Art in Public Places: Follow-Up Community Input Survey for the Justice Center Wall

Q1 How do you feel about Design 1?

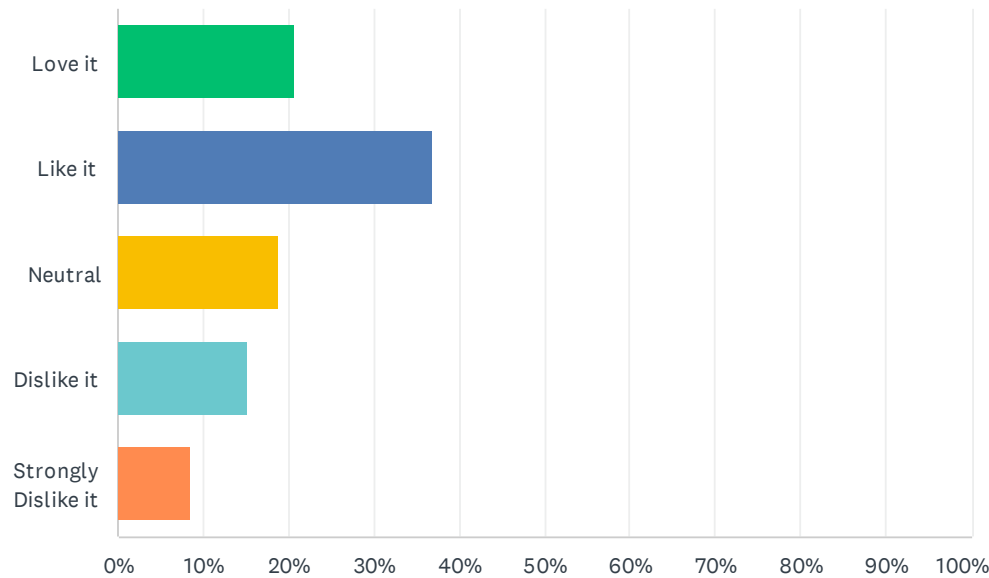
#	ADDITIONAL COMMENTS	DATE
1	Butterfly and roadrunner are disproportionally large.	7/20/2025 8:20 AM
2	The roadrunner is strangely out of scale and too dominant. The apricot blossoms also look out of scale. The background is too abstract and more suggestive of low altitude scrub lands rather than the high mesa pinon/ponderosa that can be found in the heart of Los Alamos.	7/19/2025 12:24 PM
3	Too plain and dont feel road runner is that common in Los Alamos, have seen them in Barranca but lots more in Las Cruces and even ABQ.	7/18/2025 8:40 PM
4	Looks like there is a saguaro cactus in the background? Which does not grow here	7/18/2025 11:13 AM
5	It is tacky. The colors are too bright, Gaudy Garish.	7/15/2025 9:00 AM
6	Unprofessional and not a representation of NM	7/13/2025 10:40 PM
7	I like design #2 much better.	7/13/2025 5:58 PM
8	Not really what I'd call "cultural" references -	7/13/2025 8:54 AM

9	Roadrunners are not common in Los Alamos, and it is brown and dusty in background. Better reflects the valley and great NM, not Los Alamos.	7/13/2025 8:11 AM

10	Looks to be generic southwest and Sonora desert.	7/12/2025 6:13 PM
11	Colors not vivid enough.	7/12/2025 1:03 PM
12	I like that it's more understated, not too chaotic. Design elements aren't competing with each other. Change the roadrunner to something from our local fauna, and this will be a winner.	7/12/2025 10:22 AM
13	Weird clouds and weird white outlines around some of the birds. Do we have roadrunners in this area? I have seen them around Albuquerque but not here.	7/12/2025 10:04 AM
14	There are road-runners in WR but not in LA	7/12/2025 8:35 AM
15	Doesn't reflect Los Alamos	7/12/2025 6:36 AM
16	don't like the abstract background. roadrunner too large.`	7/12/2025 6:04 AM
17	A bit too reflective of the desert landscape rather than the high desert mountains of LA. Not too many roadrunners in Los Alamos. It seems more reflective of Santa Fe or Albuquerque	7/12/2025 4:55 AM
18	There are still saguaro cactus featured in the center and far right in light beige. PLEASE, the state of New Mexico does NOT have saguaro cacti! PLEASE do not embarrass Los Alamos County with such an inaccurate, unscientific depiction. We obviously hold science to a high standard here. Just look at the nature center. We'll be the laughingstock of well-educated people, residents and other. PLEASE don't give us another reason to be disappointed in our art in public places.	7/11/2025 9:13 PM

19	I like it, but it's kind of a cliché.	7/11/2025 8:35 PM
20	I wouldn't hate it if it was chosen. I love the roadrunner. I don't like all the cacti. To me Los Alamos is more ponderosa pines than cacti	7/11/2025 7:39 PM
21	Roadrunner seems very fitting.	7/11/2025 6:36 PM
22	I don't see it as reflective of Los Alamos. We rarely see a roadrunner and it dominates the scene.	7/11/2025 6:30 PM
23	not very vibrant	7/11/2025 4:54 PM
24	We do not have saguaro cactus in Los Alamos as in the background of this sample!!!	7/11/2025 4:35 PM
25	Presents a clear message	7/11/2025 4:22 PM
26	Roadrunner is not a common bird on this plateau, seen 2 in 30 years. I prefer a little less brown.	7/11/2025 3:35 PM

Q2 How do you feel about Design 2?

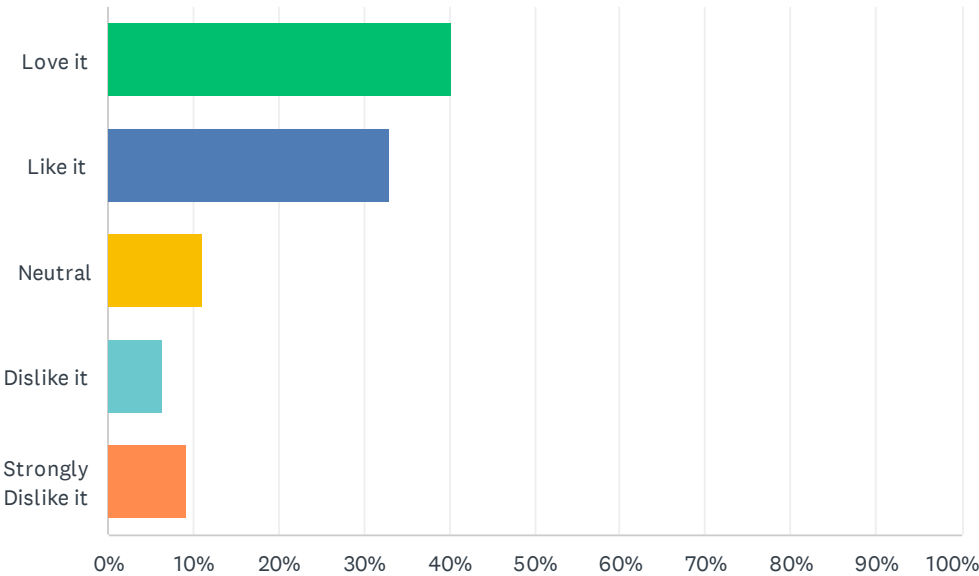
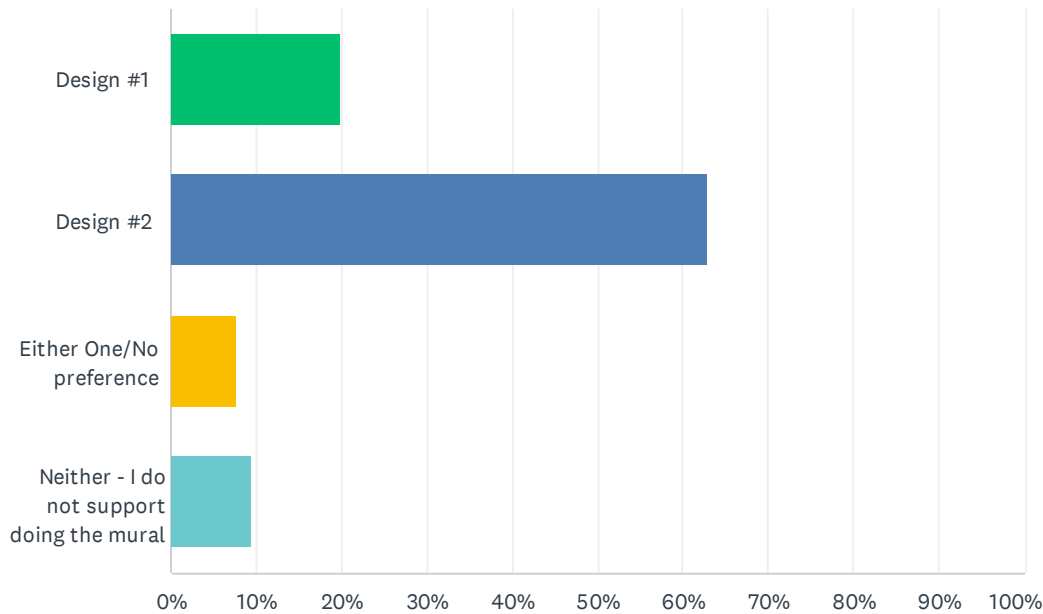
#	ADDITIONAL COMMENTS	DATE
1	Butterfly is disproportionally large.	7/20/2025 8:20 AM
2	The cliff faces (as one sees at Anderson Overlook) aren't as deep red as portrayed, but otherwise this design captures their appearance. The tanager, towhee, raven and mammals can be found here and well-rendered. The general background is much more suggestive of our environment than that shown in design 1, but I'd prefer smaller and fewer apricot blossoms.	7/19/2025 12:24 PM
3	Lots of nature, but wonder if too many items so may be too distracting for drivers going 30-35 mph on Trinity (best for viewing for pedestrians. Walking by or in and out of building.	7/18/2025 8:40 PM
4	Love the picture of the canyon being included and love the antelopehorn milkweed	7/18/2025 11:13 AM
5	I love how it is more area specific to the Los Alamos area	7/16/2025 6:54 PM
6	Comment from above stands. The Justice Center is one of our few classy buildings that gets modern NM style right. And then we want to go and do this? Stay in a SW color palette. This looks like primary color clipart hell. Or get the middle school art students to come and do it. That would be the only excuse for something like this.	7/15/2025 9:00 AM

7	Not representative of NM	7/13/2025 10:40 PM

8	Its too busy	7/13/2025 9:18 PM
9	Love, love, love this one!	7/13/2025 5:58 PM
10	I wish more of the valley view was showing but I like that this one is more colorful and contains at least some representation of our amazing view across the Rio Grande valley.	7/13/2025 8:54 AM
11	Pretty colors and love the emphasis on birds, flowers, deer and one of our beautiful cliffs in the background.	7/13/2025 8:11 AM
12	Design 2 evokes local vibes and seems to be a better composition of elements. It seems more vibrant with the depths of the background which I hope is not just a variation in sky colors but is the view of the plateaus seen looking west on NM 502 on the hills around El Rancho in the late afternoon or early evening. The whole range of colors gives much more depth and gives the eye something new to explore in each glimpse. Well done!	7/12/2025 10:09 PM
13	Better representation of northern New Mexico and Los Alamos.	7/12/2025 6:13 PM

14	What happened to the road runner?	7/12/2025 6:02 PM
15	Love the variety of plants and animals. Much more vivid and interesting than 1. The western tanager is awesome. Yes please!!!!	7/12/2025 1:03 PM
16	Too much going on, and the scales and colors of the different elements seem to clash. There's nowhere for my eyes to rest. The elements are individually cool (tanager, pinon, mesas, raven, bear...), but the combination is visual cacaphony.	7/12/2025 10:22 AM
17	Why are there white outlines around the flying birds. That looks weird and distracts from the rest of the artwork.	7/12/2025 10:04 AM
18	Love the wildlife represented in this version.	7/12/2025 9:19 AM
19	Perhaps a different artist	7/12/2025 8:51 AM
20	This is a better reflection of Los Alamos County wildlife.	7/12/2025 8:35 AM
21	Shows wildlife that represents what you see in Los Alamos	7/12/2025 6:36 AM
22	I feel like the second design better represents Los Alamos.	7/12/2025 6:11 AM

23	more colorful, balanced. love realistic background.	7/12/2025 6:04 AM
24	Now that's Los Alamos! Love the deer, the mesa, the bear, etc. To me, this is Los Alamos.	7/12/2025 4:55 AM
25	This is a much better design than before. At least its components are more relevant to Los Alamos County than #1. -- I still don't understand why an Austin, TX artist was selected, who is neither local nor regional, as put forth in the APP mission statement. There are local artists who could do something similar in mosaic tile, if not in Los Alamos, in Santa Fe or Albuquerque. This makes the public think this is a sweetheart deal of some sort. I'd suggest that APP be more attentive to its mission statement. Mid-to-high five-figure expenses of public money require accountability to taxpayers.	7/11/2025 9:13 PM
26	Too busy	7/11/2025 9:08 PM
27	I like this one best, but I can't see the bear. It sort of looks like a grizzly, not the black bears marauding our trash. Can she fix the bear to ensure it doesn't look like a grizzly? Of course the iconic view of our canyon is what I especially like about this one.	7/11/2025 8:35 PM

28	I like the bear and deer and all the bird species. The background is more representative of Los Alamos.	7/11/2025 7:39 PM
29	Deer are everywhere in Los Alamos.	7/11/2025 6:36 PM
30	This is Los Alamos. Mesa, deer high ground, woodpeckers. Represents what we see every day. Thanks for the survey.	7/11/2025 6:30 PM
31	Looks like an aquarium scape	7/11/2025 6:28 PM
32	This one feels too busy. A collage of the animals sounds great in theory but this representation comes across very cluttered.	7/11/2025 5:51 PM
33	much more colorful	7/11/2025 4:54 PM

34	Would be better if the middle birds and flowers were downsized a little. They are good and shouldn't be downplayed because they are disproportionate and distracting to the overall feeling.	7/11/2025 4:22 PM
35	Represents Los Alamos better in choice of critters and pine bough.	7/11/2025 3:35 PM
